To: Members of the Architectural Review Board (ARB)
From: Jennifer M. Rauch, AICP, Director of Planning
Date: December 19, 2024
Initiated By: Sarah Tresouthick Holt, AICP, ASLA, Senior Planner
Re: 134 S. Riverview Street Deck Cover

BOUNDARY SURVEY
SOUTH RIVERVIEW CONDOMINIUM
 C.P.B. 85, PG. 24
 INS. 200002080026846
 CITY OF DUBLIN, FRANKLIN CO., OHIO

FRONT ELEVATION

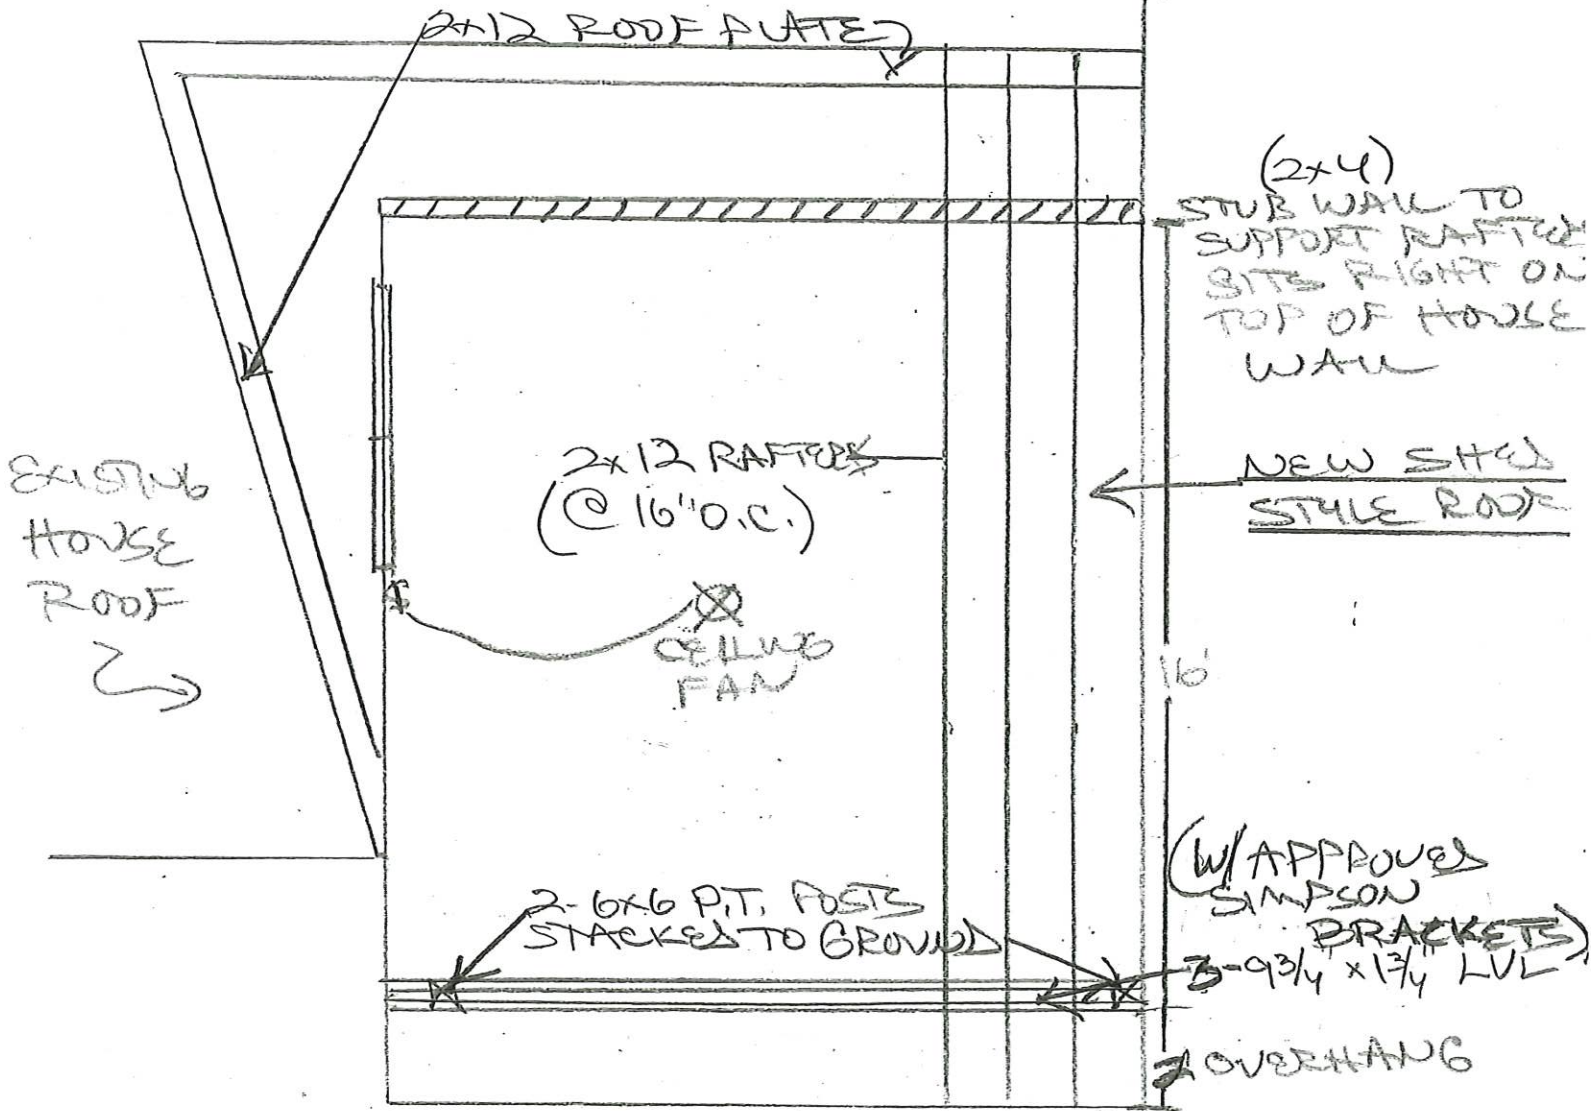
The proposed shed roof addition is appropriate for the Background building and will not affect the overall building envelope. Materials and construction will match those of the existing house. Planning has administratively approved the request.
